## 6 Technical Feasibility of NG-EPON

### 6.5.6.4 Outside Plant

Figure 132: Attenuation and chromatic dispersion in different fiber types

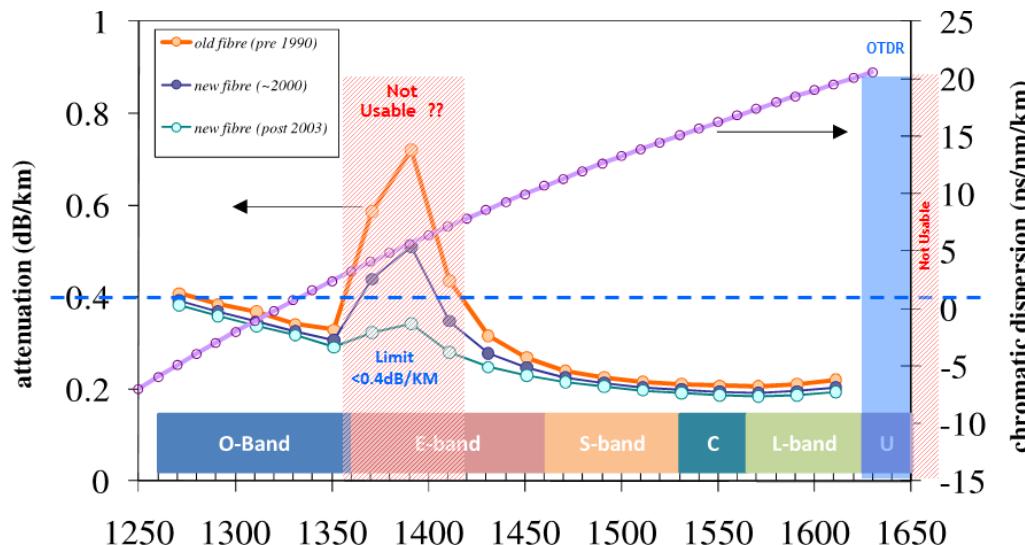
Commented [MH1]: We removed these at the last meeting

Commented [MH2]: Figure 32 does not have information allowing us to draw this conclusion anymore

**Figure 38: Spectrum allocation bands for optical access defined in IEEE 802.3, SCTE, and ITU-T**

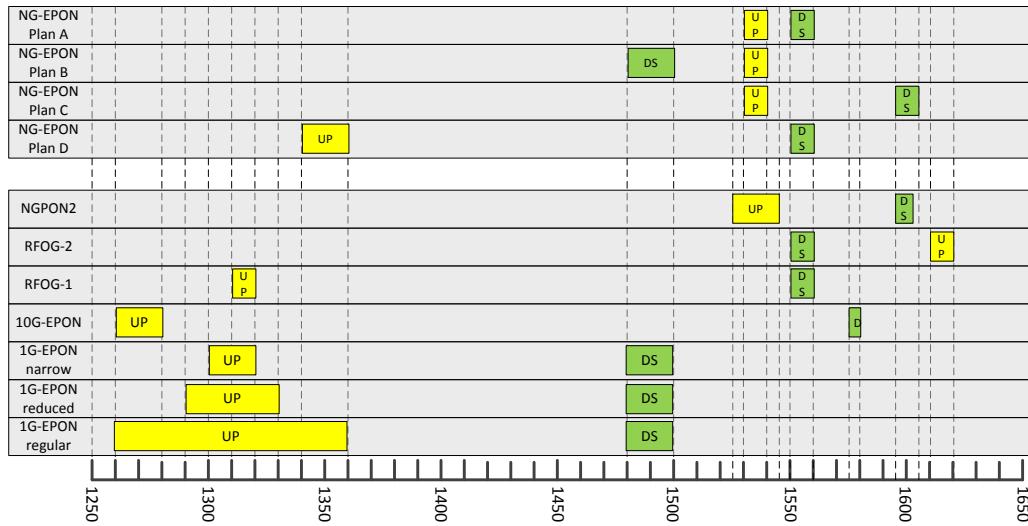
~~Also, of note is the fact that the continued use of 1610 nm analog return channel for RFoG impedes deployment of next generation ITU-T systems, overlapping with the downstream channel of TWDM option.~~

**Commented [MH9]:** It is hardly coexisting with 1610 nm upstream RFoG option
